ADDENDUM NUMBER 2

Project: C. Wayne Stevens, Jr. Public Safety Facility
Highlands Business Park – Owens Drive
Glade Spring, VA 24340

Date: June 5, 2026

DATE	01-30-2026
NO.	REVISION DATE
1	
2	
3	
SHEET	C101
DRAWN BY	MPH
CHECKED BY	MRL
PROJECT NO.	TLG-2515
THE LANE GROUP INC.

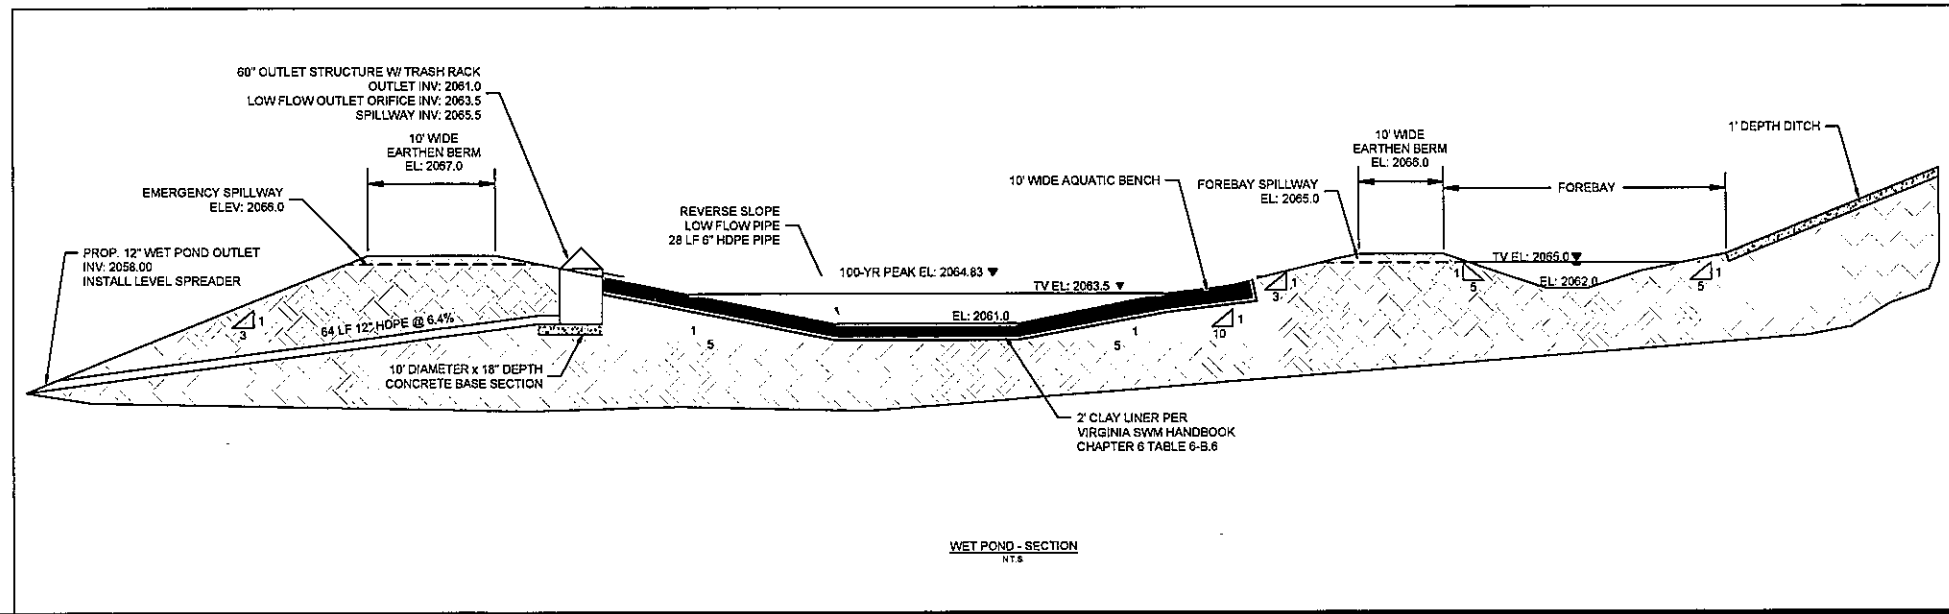
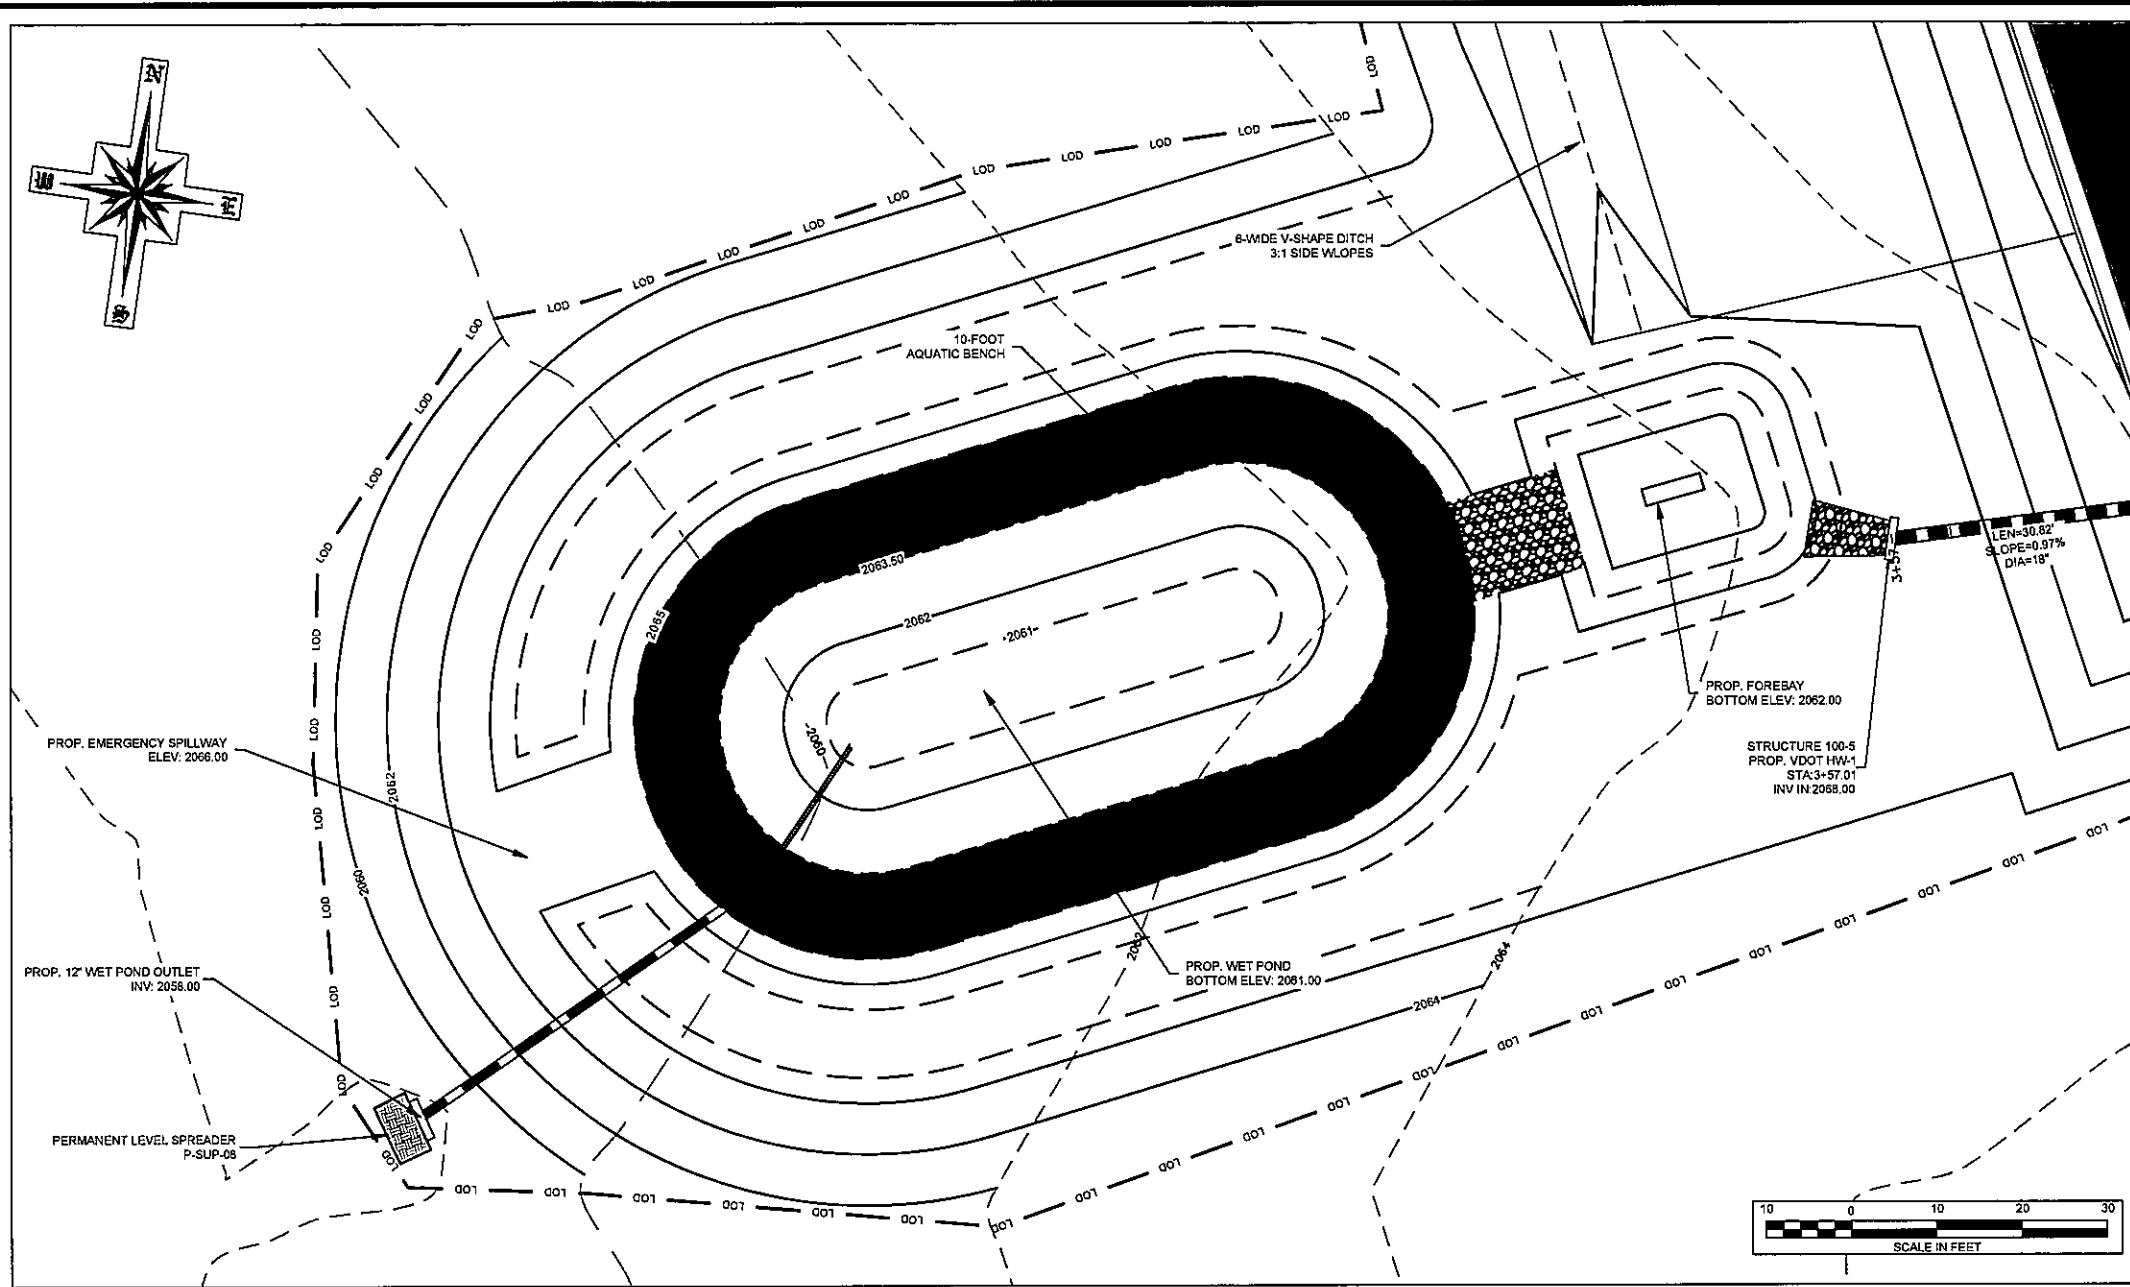
2. **Refer to Drawing C101, "Site / Grading Plan":** Drawing C101 issued previously has been replaced with this version, dated 06-05-2026. The stormwater structure previously located near the Generator has been deleted. Additional spot elevations and flow arrows have been added for clarification. Pond grading has been updated. Level spreader, P-SUP-08, has been added.

DATE	01-30-2026
NO.	REVISION DATE
1	
2	
3	
SHEET	C203
DRAWN BY	MPH
CHECKED BY	MRL
PROJECT NO.	TLG-2515
THE LANE GROUP INC.

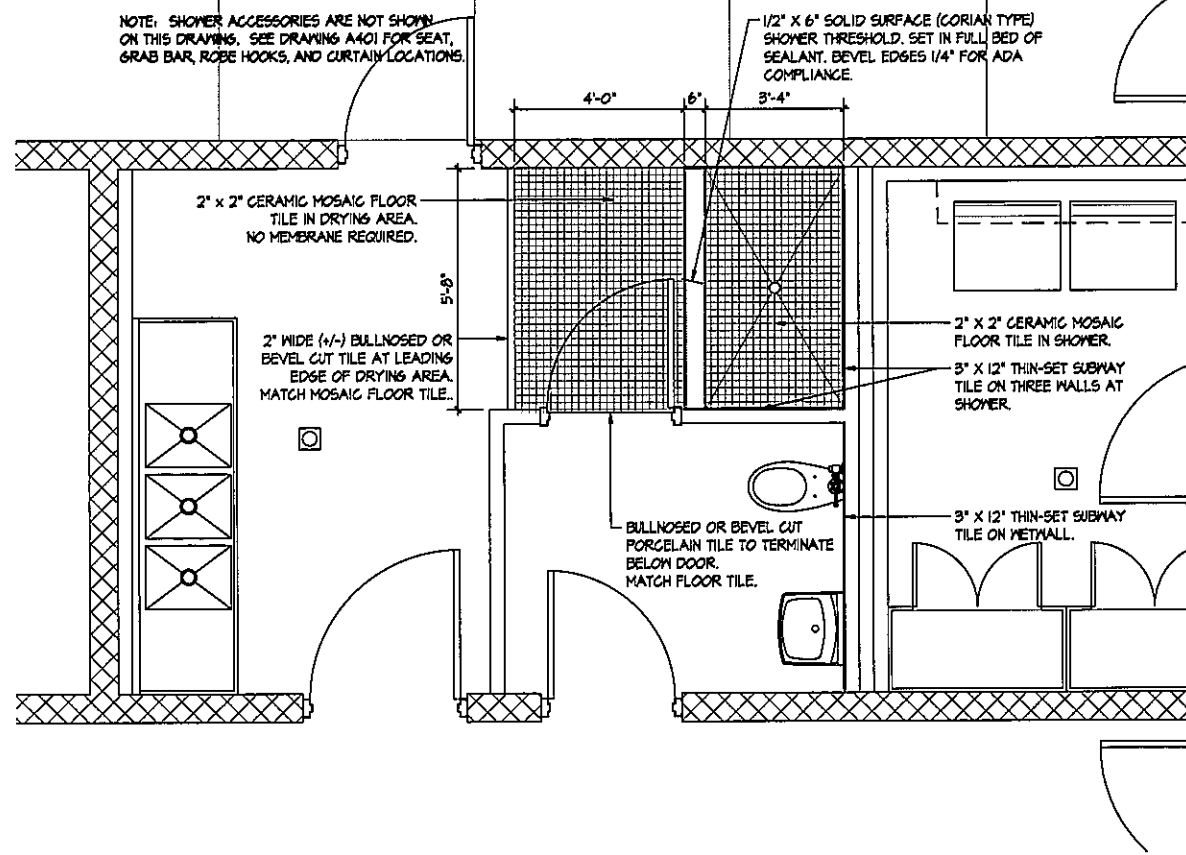
3. **Refer to Drawing C203, "Wet Pond Details":** This Drawing is added by this Bid Addendum. It is, however, mislabeled as "Site/Grading Plan." This pond detail sheet provides additional information about pond grading and the outlet structure.

DATE	01-30-2026
NO.	REVISION DATE
1	A702 ADDED 06/05/2026
2	
3	
SHEET: A702	
DRAWN BY: DMW	CHECKED BY: MRL
PROJECT NO: TLG-2515	
THE LANE GROUP INC.

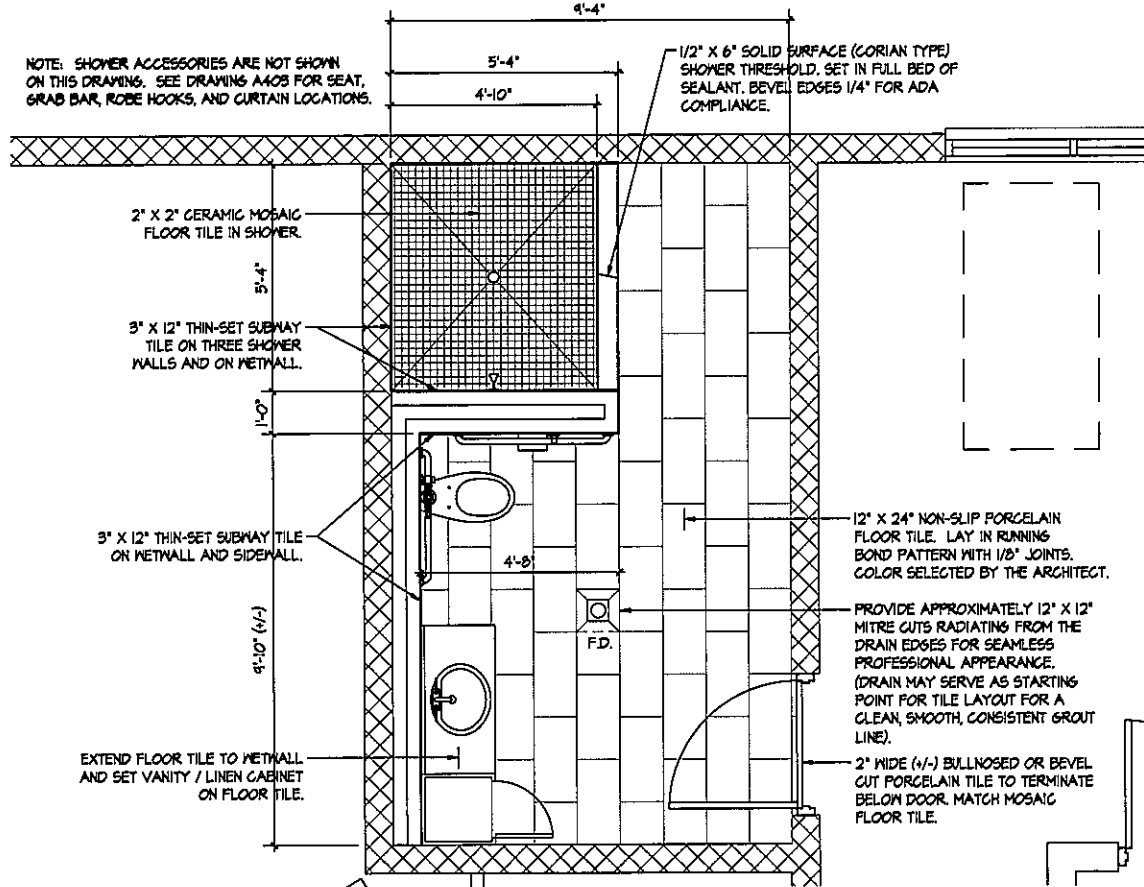
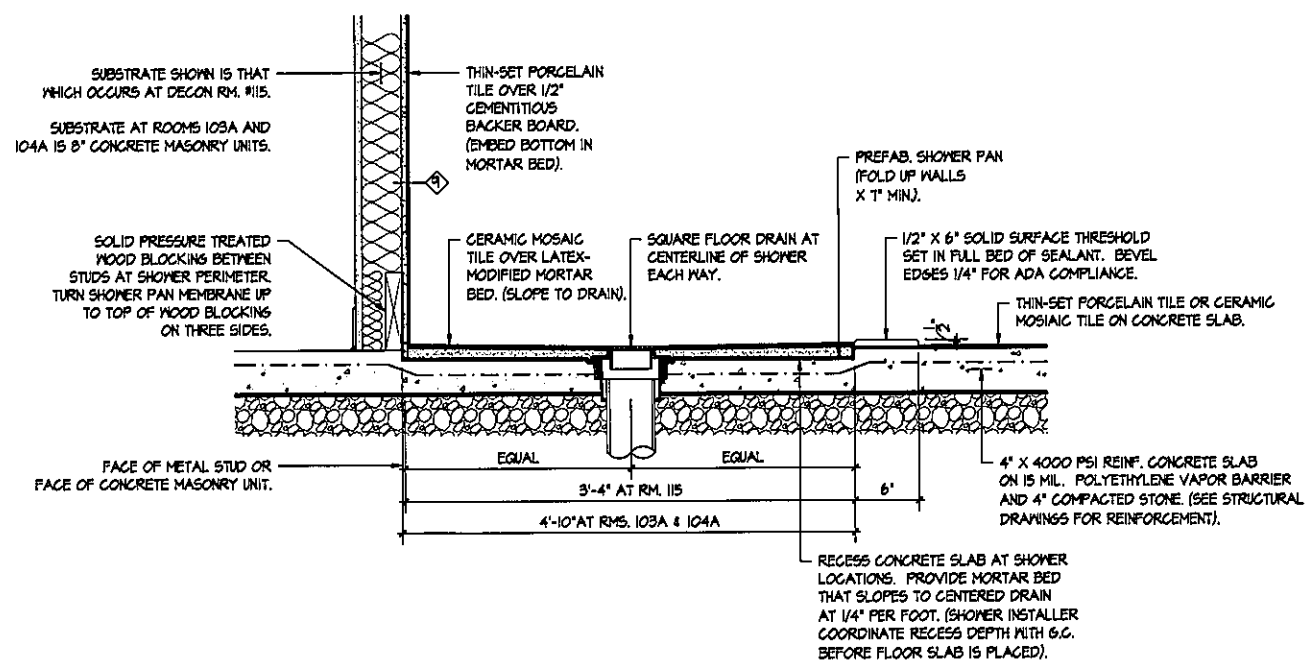
4. **Refer to Drawing S101, "Foundation Plan":** At the three shower locations, (Rooms 103A, 104A, and 115), recess the floor slab to accommodate a tile mud bed. See new Drawing A702 for recessed slab dimensions.

7. **Refer to Drawing A303, Building Section – North":** Drawing indicates a 4-inch-high curb at the two shower locations. Delete the curb. See new Drawing A702 for shower details.

9. **Refer to Drawing A702, "Finishes at Ceramic Tile Locations":** Drawing A702 is added by this Bid Addendum.
10. **Refer to Drawing A702, "Finishes at Ceramic Tile Locations":** Bidder noted that polished concrete floors are not practical at shower and potentially wet floor locations. Drawing A702 is added to indicate where ceramic mosaic tile and porcelain floor tile should be added to the Scope of Work. Drawing A702 also indicates typical shower section.
